Fermilab

6/20/91
TS-SSC 91-127

To: Wally Zimmerman
From: Jim Strait
Subject: Change in shim for long 50 mm outer coil mold

Figure 1

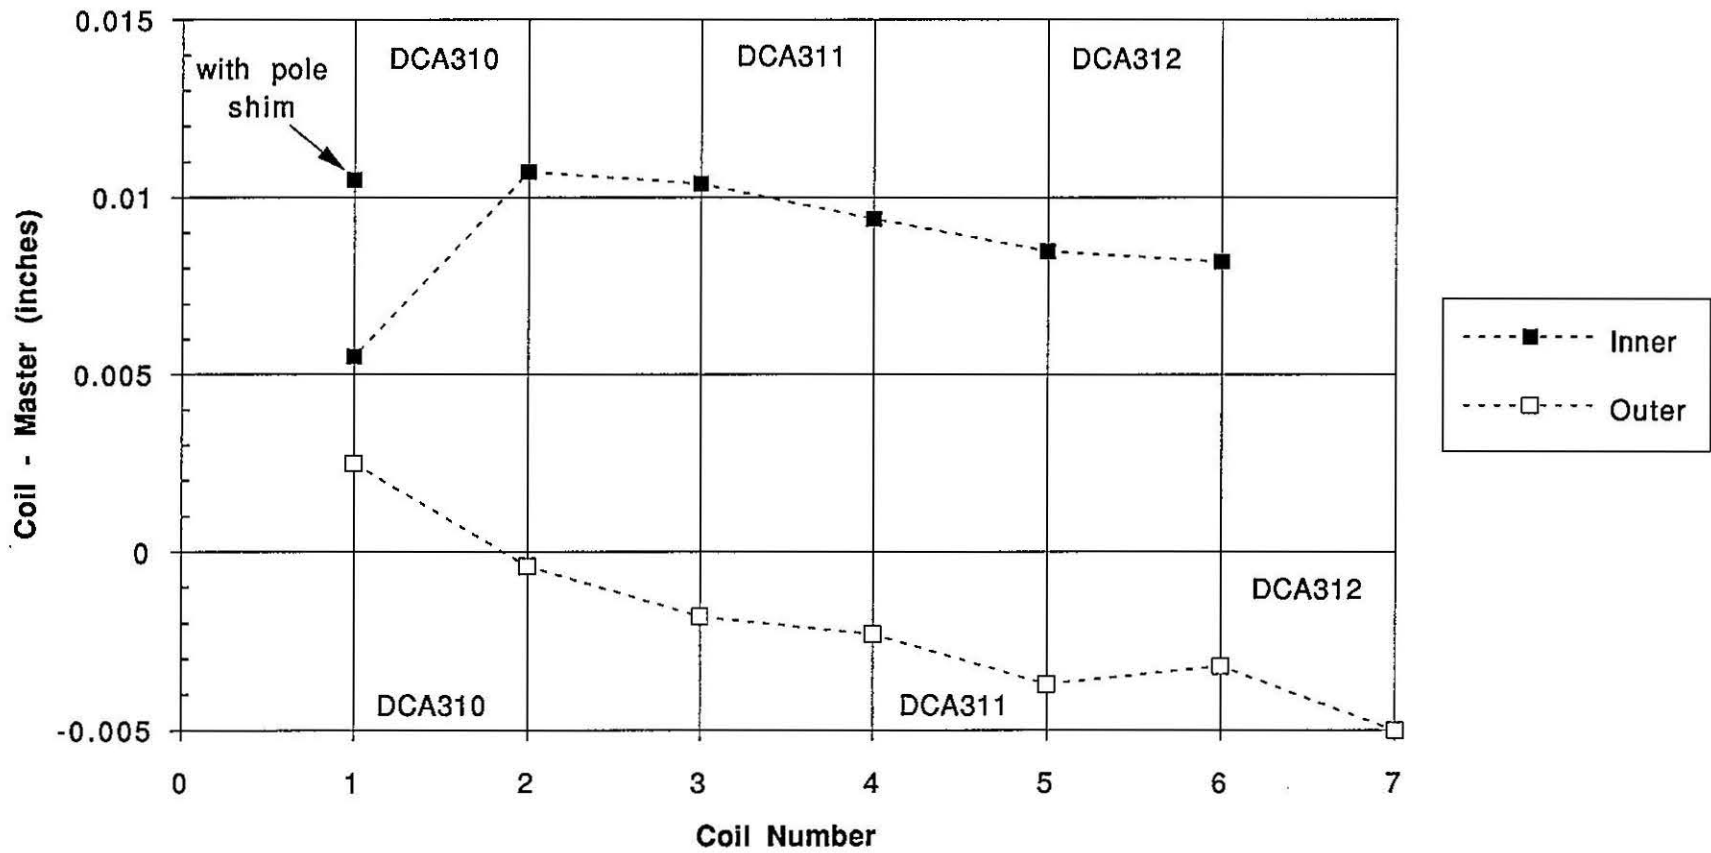
Over the course of long coil production, the average size of both the inner and the outer coils has become progressively smaller. Fig. 1 and Table I shows the average coil size versus coil number and indicates which coils belong to which magnet. Between inner coils 1 and 2 (15M-50-1001 and -1002) the mold shim was increased by 5 mils and between outer coils 1 and 2 the outer mold shim was decreased 3 mils. Since then the mold conditions have remained nominally constant, but the inner coil size has decreased about 2.5 mils and the outer coil size has decreased almost 5 mils. The cause of this decrease is not known.

The most recent inner coils still lie within the target range, so no inner mold shim change is needed at this time. However, if the trend towards smaller coil sizes continues, the mold cavity may have to be increased later. The most recent outer coil (15M-50-2007) is 1 mil smaller than the lower bound and the two previous coils (2005 and 2006) are near the bottom of the target range. The 3 mil increase in mold cavity should put the next outer coil at or a little above the center of the target range.

The shim under the stop bar on the long 50 mm magnet outer mold should be increased from 7 mils to 10 mils starting with the next coil (15M-50-2008 for DCA313). This will give a total thickness of the stop bar plus shim of 0.250 inch.

Figure 2

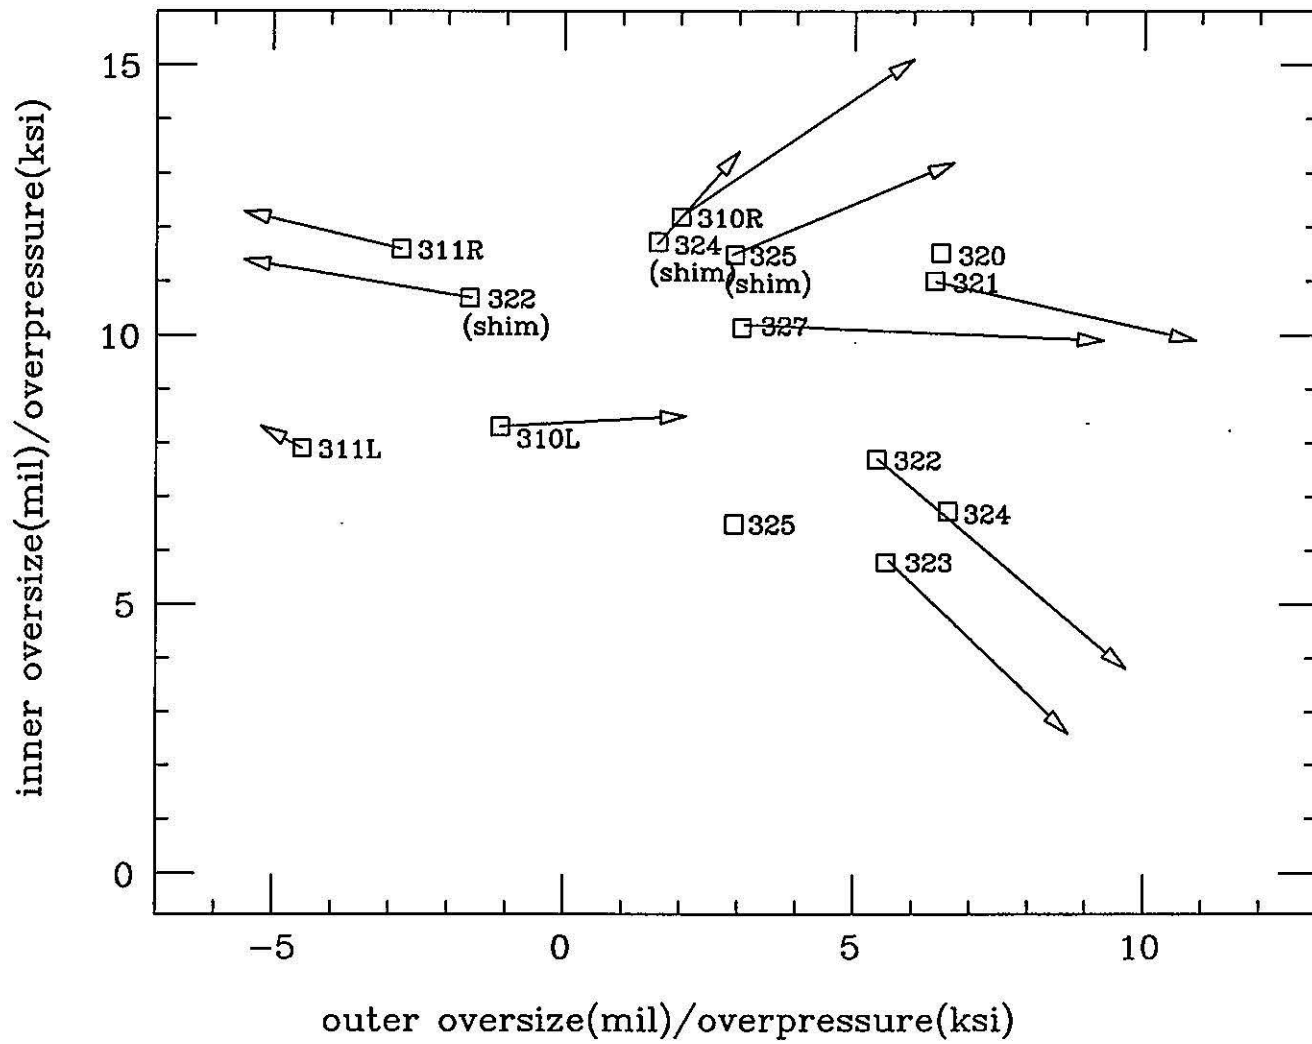
Based on experience with the short 50 mm magnets and the first two long 50 mm magnets, the target size range for inner coils is approximately +7 to +11 mils relative to the master and for outer coils is approximately -4 to 0 mils relative to the master. Fig. 2 ("Wake plot[1]") summarizes the size and preload data for all 50 mm magnets made so far. The position of the square for each magnet gives the size relative to the master of the inner and outer coils at the strain gauge pack. The length of the arrow in each direction gives the difference between the measured coil prestress and the center of the target band: 10 kpsi in the inner coil and 8 kpsi in the outer coil. If the arrow points to the right or up, then the outer or inner prestress is above the center of the target band and therefore the outer or inner coil is must be larger than the center of the target coil size band. In the absence of measurement errors, the arrows should all point away from a common point which corresponds to "perfect" inner and outer coil sizes. From this plot it seems that the target inner coil size is about +9 mils and the target outer coil size is about -2 mils. A band of ± 2 mils about these gives the target ranges quoted above.
